Specific Design Plan Timothy Branch

SDP-1701-03

STAFF REPORT

SUBJECT: Specific Design Plan SDP-1701-03

2 - -WSSC Plan Comments

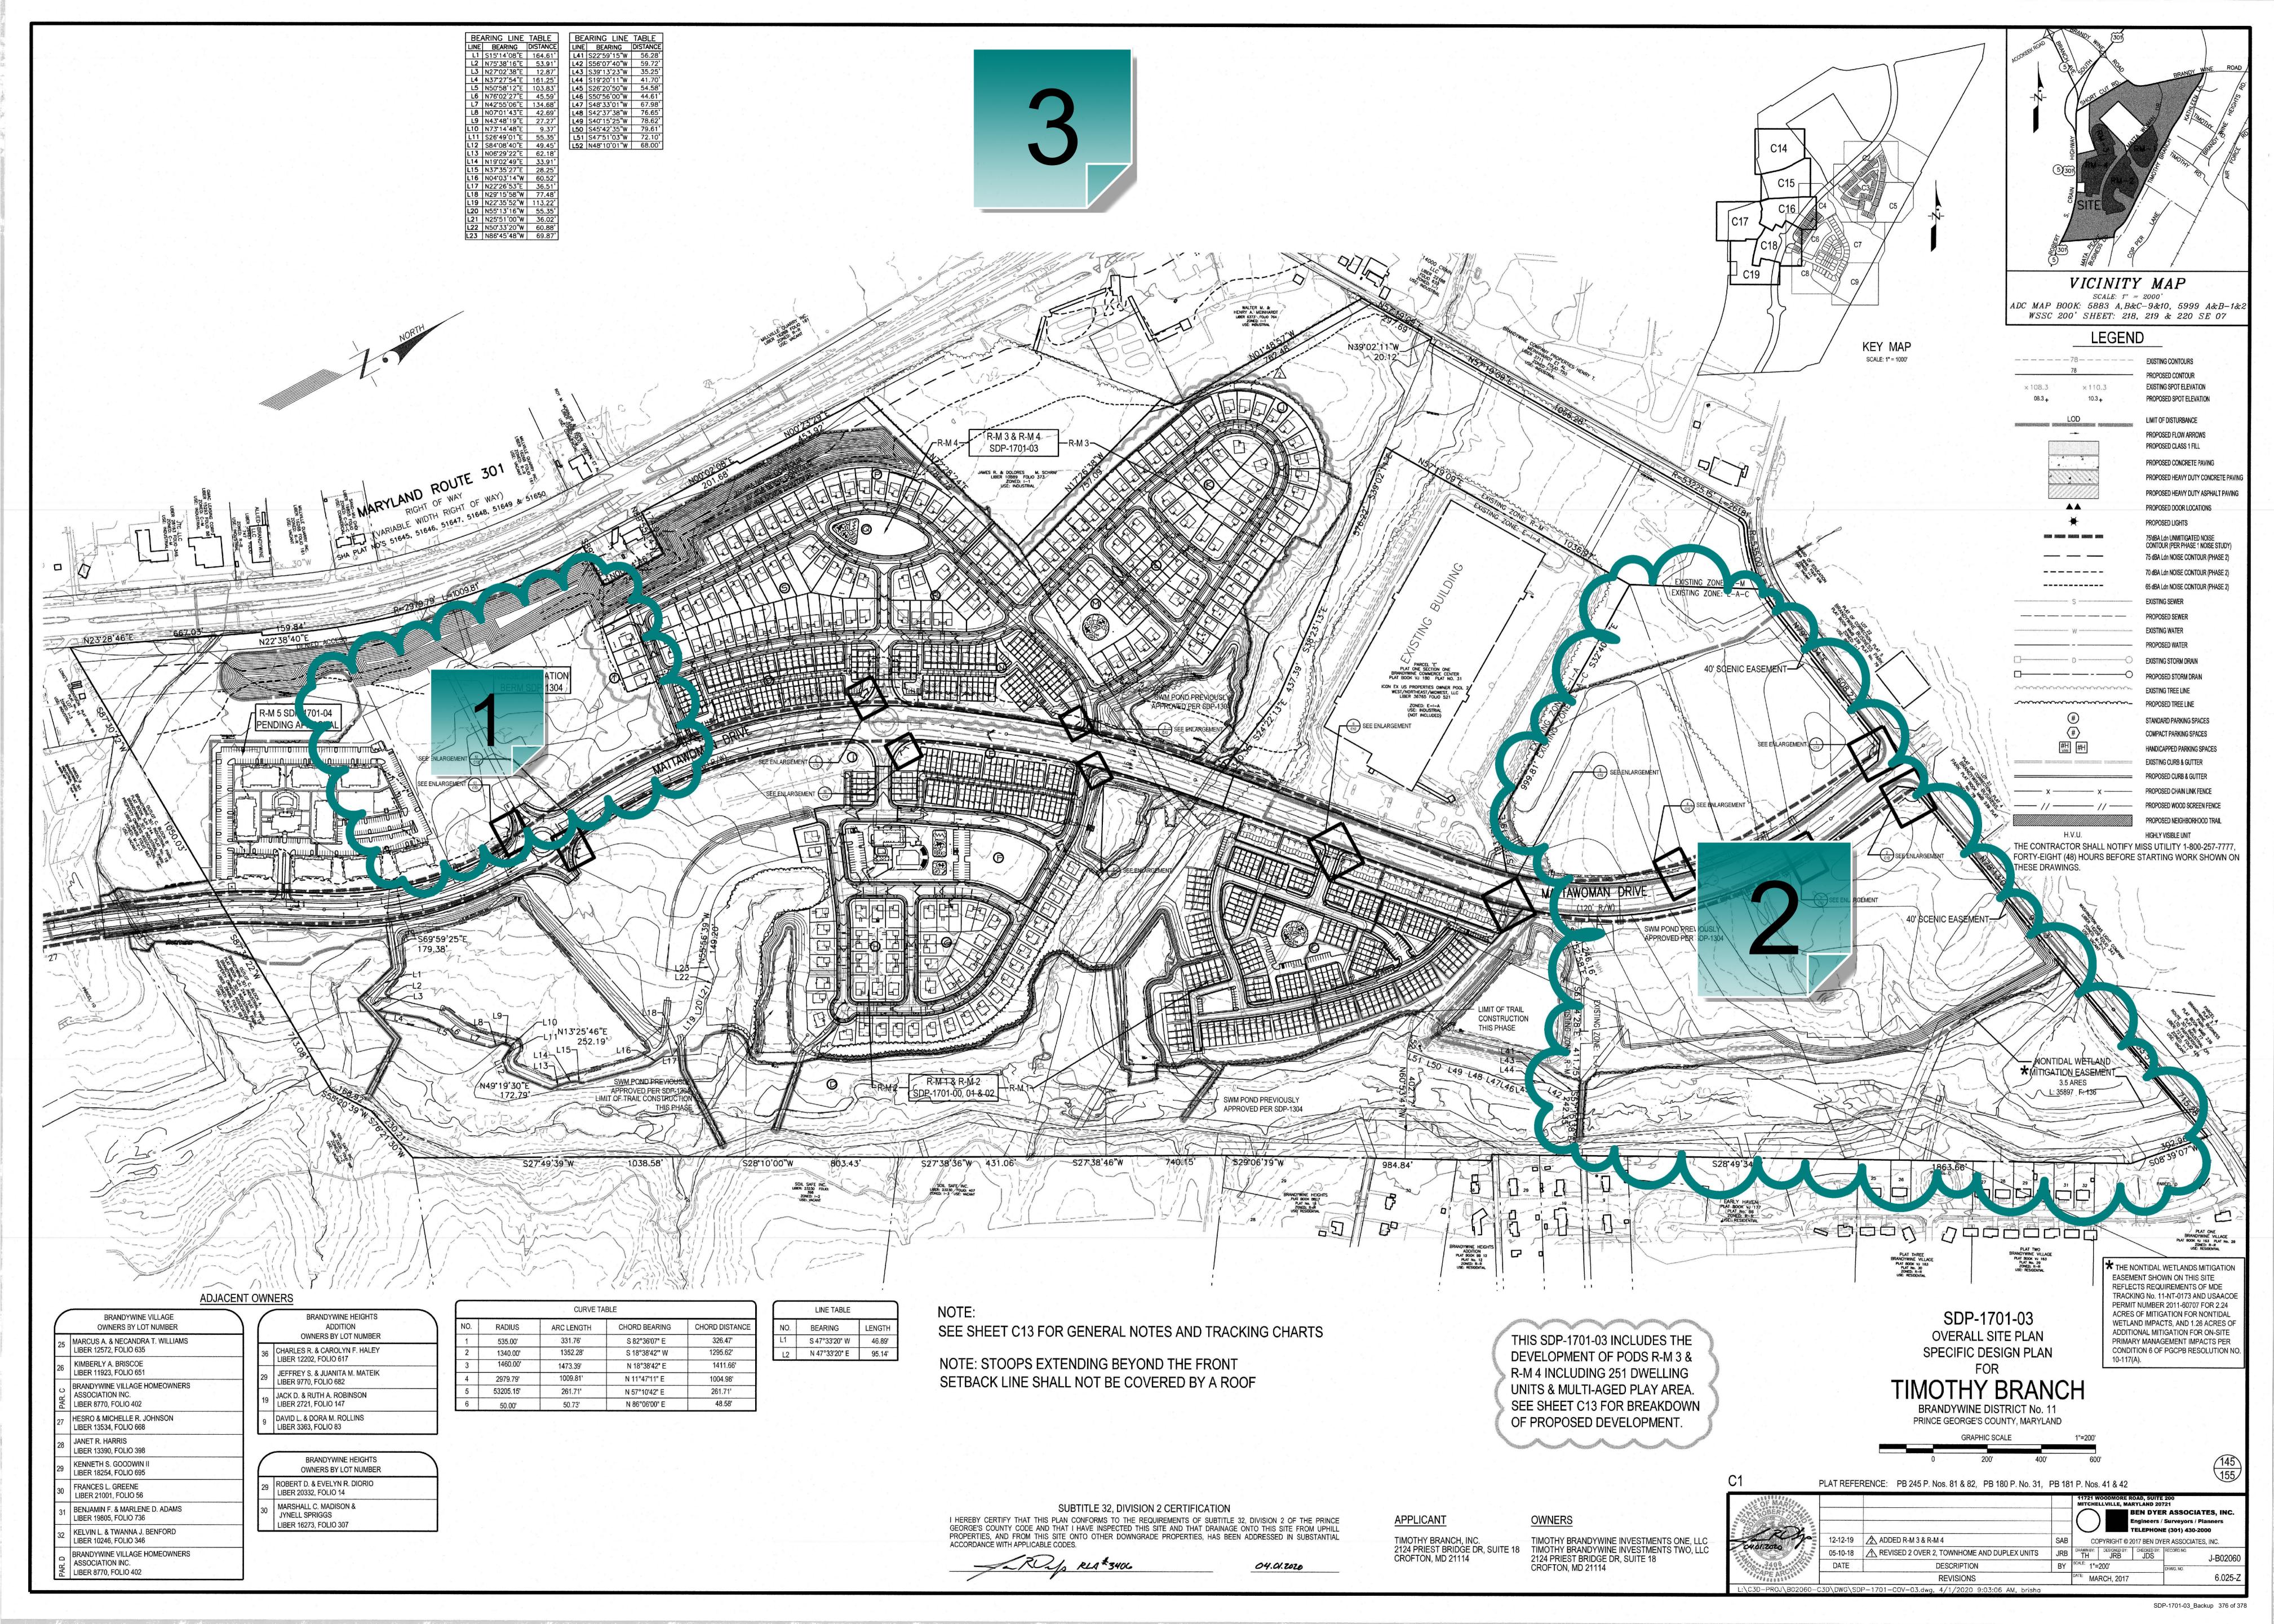
Created by: Dave Margolis On: 04/09/2020 03:01 PM
Plan #SDP-1701-03 Timothy Branch Outlots C and D
0 Replies

3 - Design Comment/Hydraulic Comments

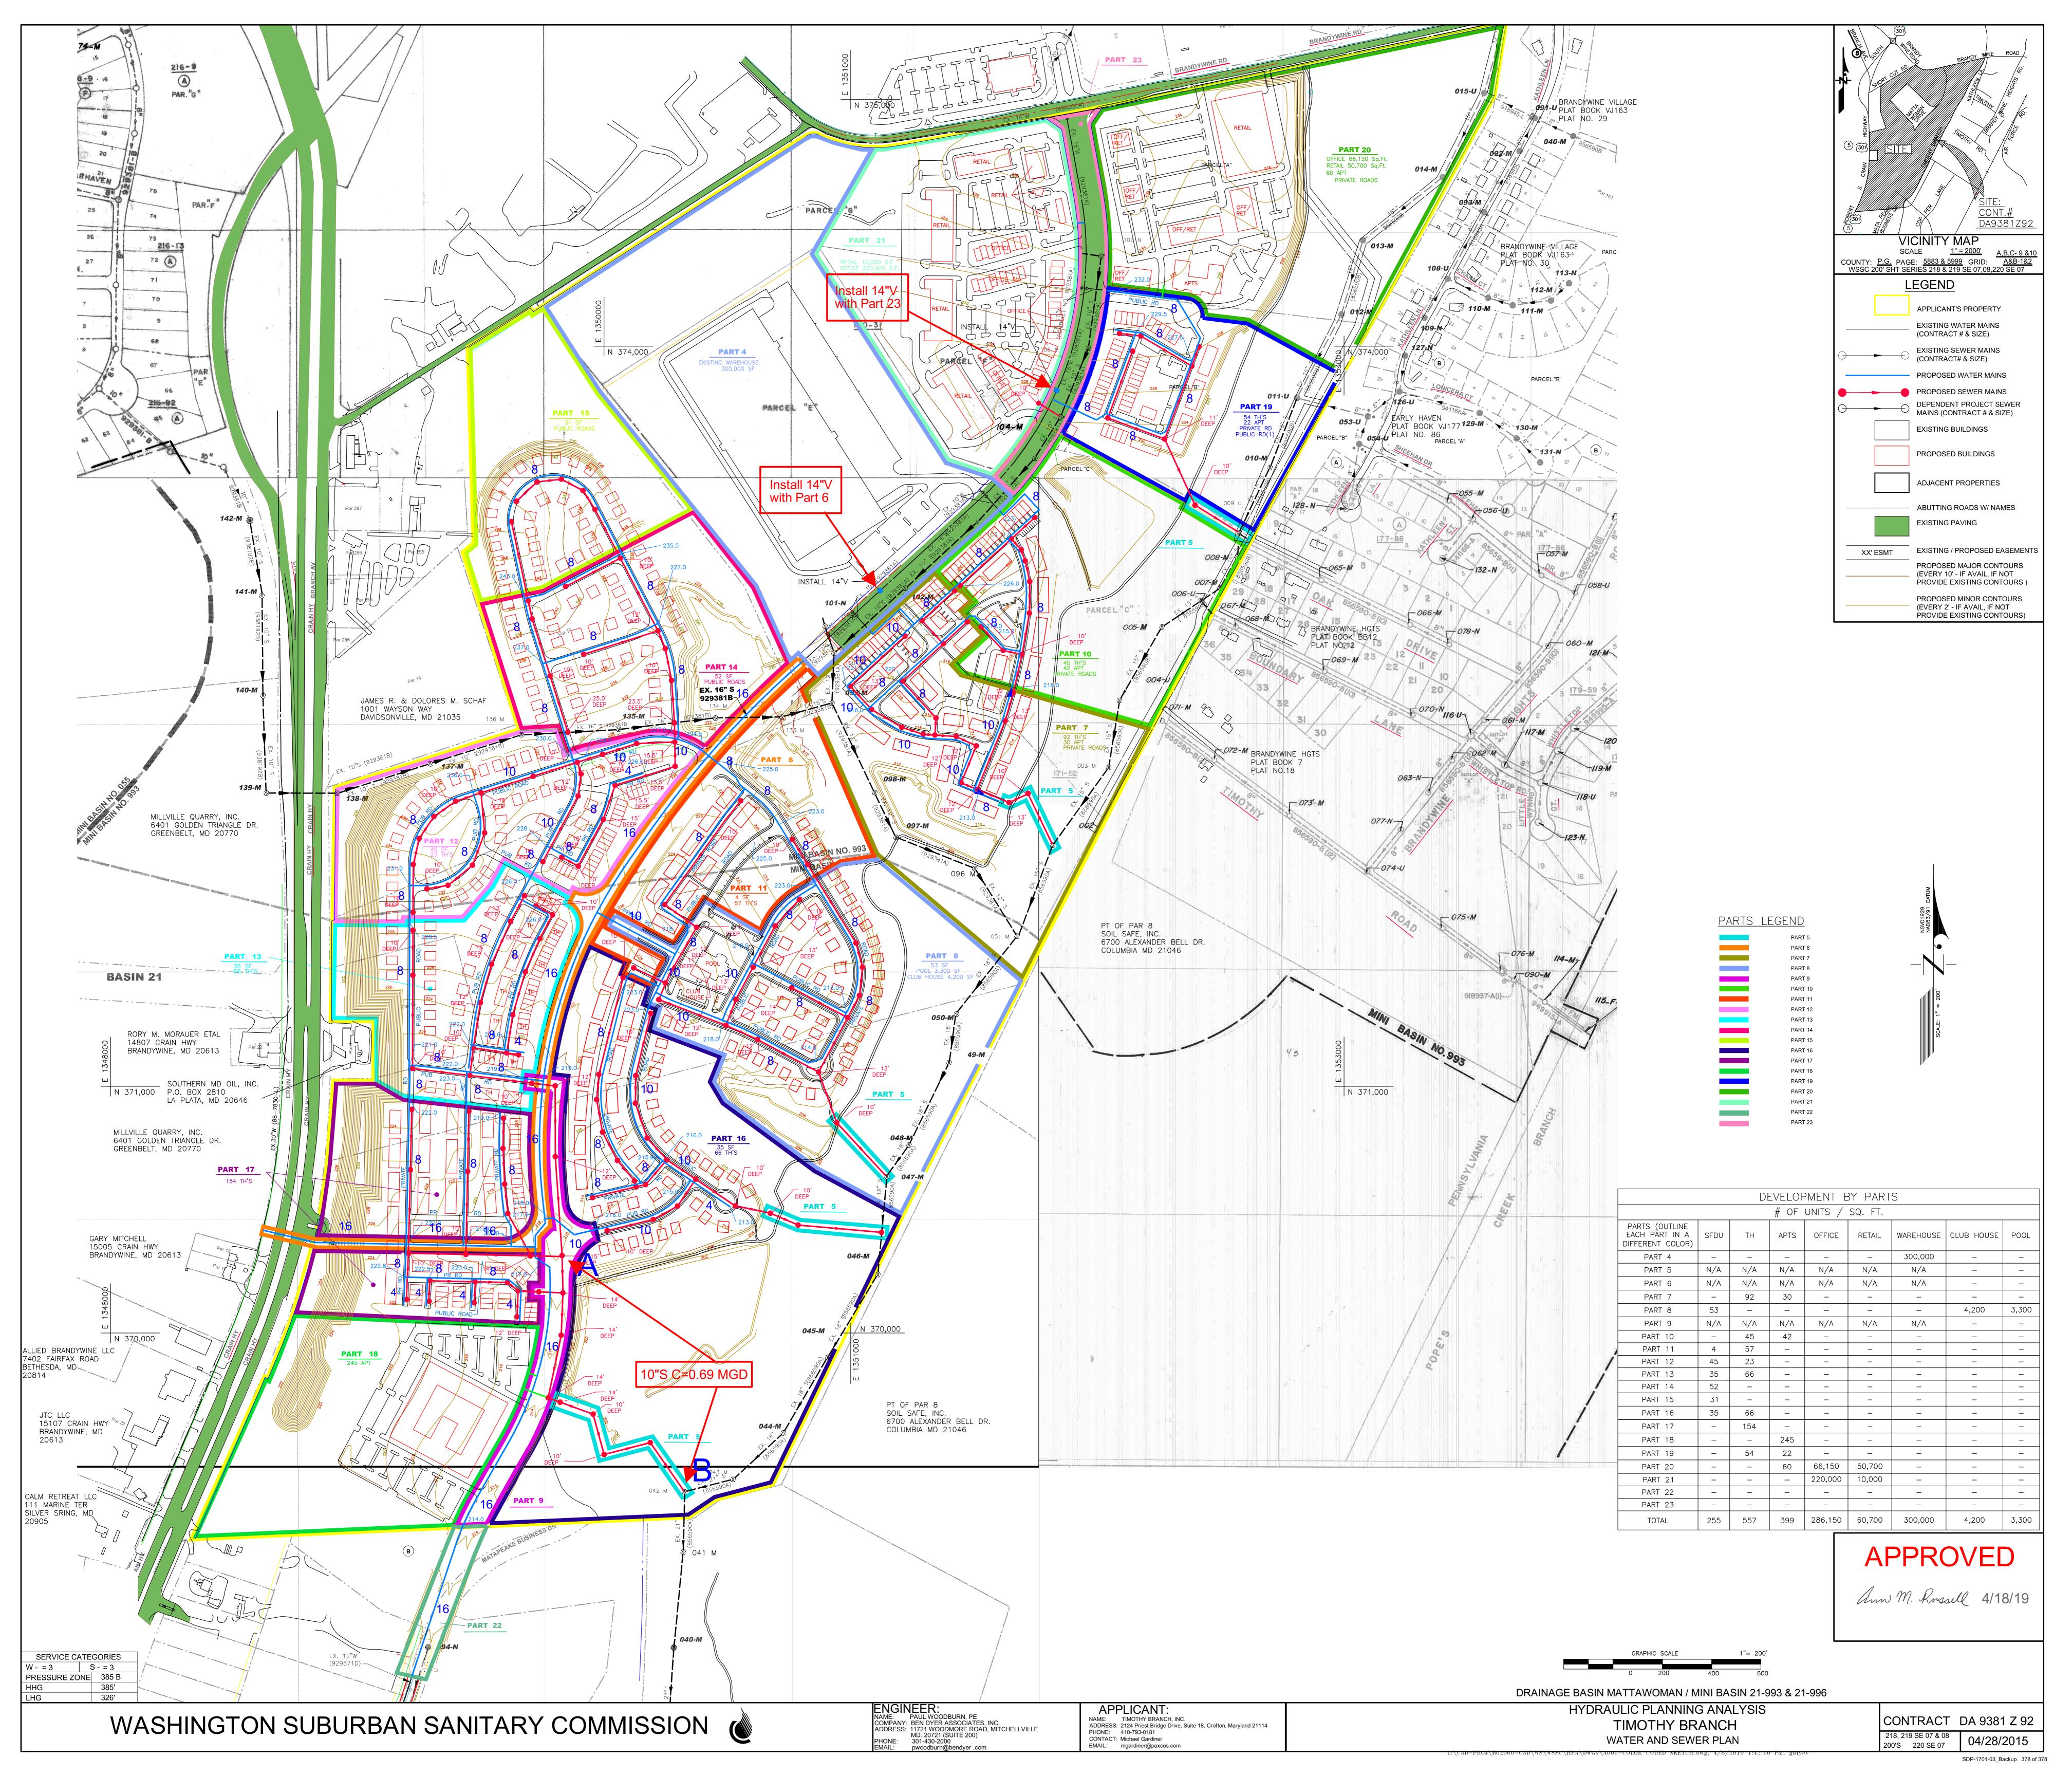
On July 6, 2017 I provided the following comments which have not altered, except that the HPA has been updated on April of 2019:

A proposed site development project was previously submitted to WSSC (DA9381Z92) and is a conceptually approved project. Contact Ann Russell at (301) 206-8823 or Ann.Russell@wsscwater.com for information.
